FILE NOTE

Project	9234 Downtown Car Park Redevelopment
Date	2 April 2026
Subject	Section 67 Request for Information
Prepared	<i>on behalf of</i> Warren and Mahoney Architects New Zealand Ltd
Distribution	Pamela Santos (Barker & Associates)

Drawing No L30.101
Revision C

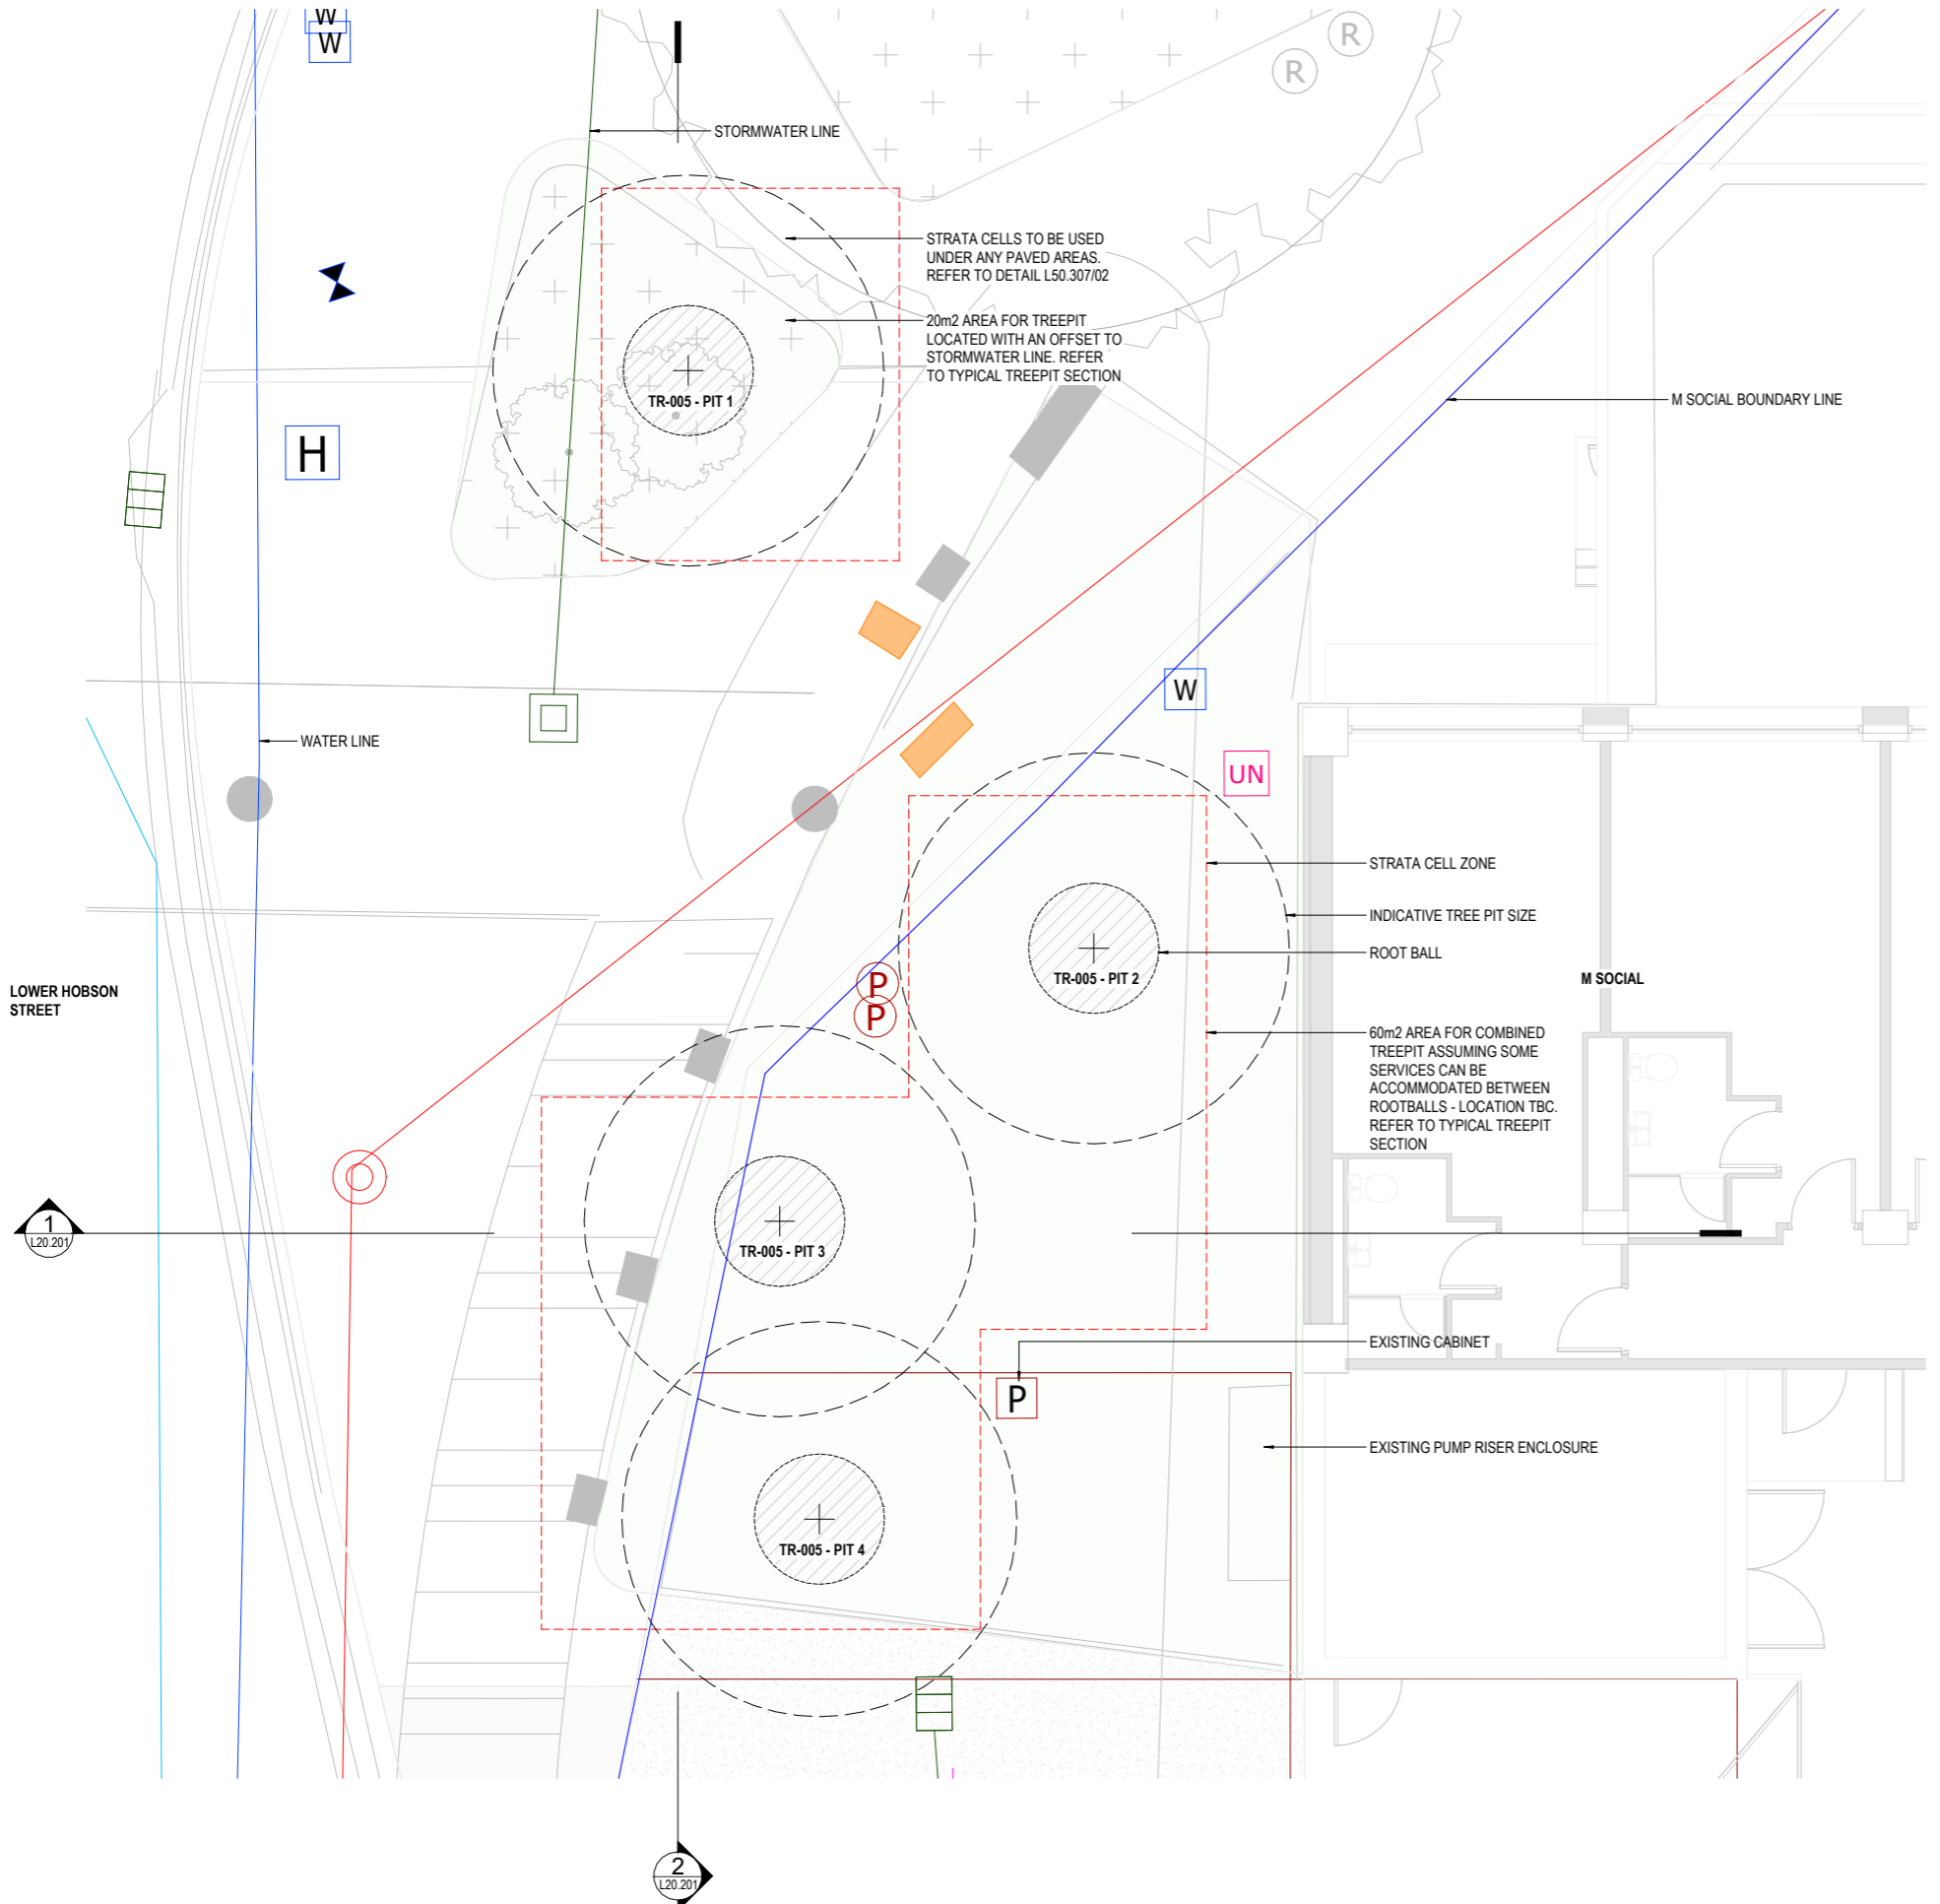
Arborist		
Item	Information Request	Design Team Response
23	<p>S67 Request for information</p> <p>Four 2000-litre trees on the corner of Quay Street and Lower Hobson Street. The ability to plant trees of this size in this location is dependent on if there are any underground obstructions or existing or proposed services. At present there are both stormwater and wastewater connections in the vicinity of these trees. It is not clear from the information provided if there is a conflict. The area provided also looks fairly small to establish four trees of this species. In comparison, there is an existing Pohutukawa to the north of the proposed planting location that occupies a similar space as the four trees proposed to be planted.</p> <p>I don't see anything within the information provided that addresses if these trees can actually be planted in this location and if the space allowed is sufficient for trees of this size. Please provide details of the ability to plant trees of this size in the space available identifying any below ground constraints.</p>	<p>A desktop review has been undertaken as part of the landscape concept design to consider placement of the proposed large pohutukawa trees and the associated tree pit volumes in relation to survey of existing underground services and the available 'before u dig' and council GIS information as summarised below.</p> <p>Evaluation of required area and volume for the proposed treepits has been based on achieving between 15m³ and 20m³ root volume per tree in accordance with the Auckland Code of Practice for Land Development and Subdivision, chapter 7: Landscape, table 4, Page 41. The tree pit construction is expected to consist of structural soil cells to form the root volume with root barriers and drainage as required</p> <p>1No. large Pohutukawa tree has been proposed within an existing planter where currently two small trees have been located (only one currently exists). The current tree pit root volume is unknown however should this treepit require reconstruction initial review suggests there is adequate space up to 20m³ within the area of the existing planter and extending below the current pavement and clear of the existing stormwater line that runs under the west of the planter. No loss of footpath is anticipated with a new tree pit to be constructed of rootcells where under the footpath.</p> <p>This tree pit is located within road reserve and would require approval from the Auckland Transport and the street tree asset owner.</p> <p>3No. further large Pohutukawa are proposed in the area south of the existing stairway to the pedestrian bridge (following removal) and the end of the M Social site currently planted with low vegetation and a series of stone boulders. Zones have been identified between existing identified services suitable to provide adequate treepit volume and up to 60 m³ in this area noting that these span the property boundary between the road reserve and M Social and extend under the footpath to achieve 20m³ per tree Should construction of the treepits be required to occur only within the M Social property then it is estimate that 15 m³ per tree could still be achieved</p>

<p>It is noted in this area that should it be required due to high services not yet identified; the volume could also be provided in an above ground planter without reduction in footpath space. This may include a raised seating edge with soil volume mounded behind and similar to the adjacent seating along quay street.</p> <p>The attached plan arrangements and details have been developed in conjunction with the project arborist to allow some flexibility in accommodating the proposed trees around existing services including the option to raise the ground level (shown as a mound) and bridge over any conflicting services to provide adequate soil volume.</p> <p><u>Refer to attached drawings</u> L30.101 rev C L30.102 rev C L20.201 rev C L50.307 rev C</p>
--	--
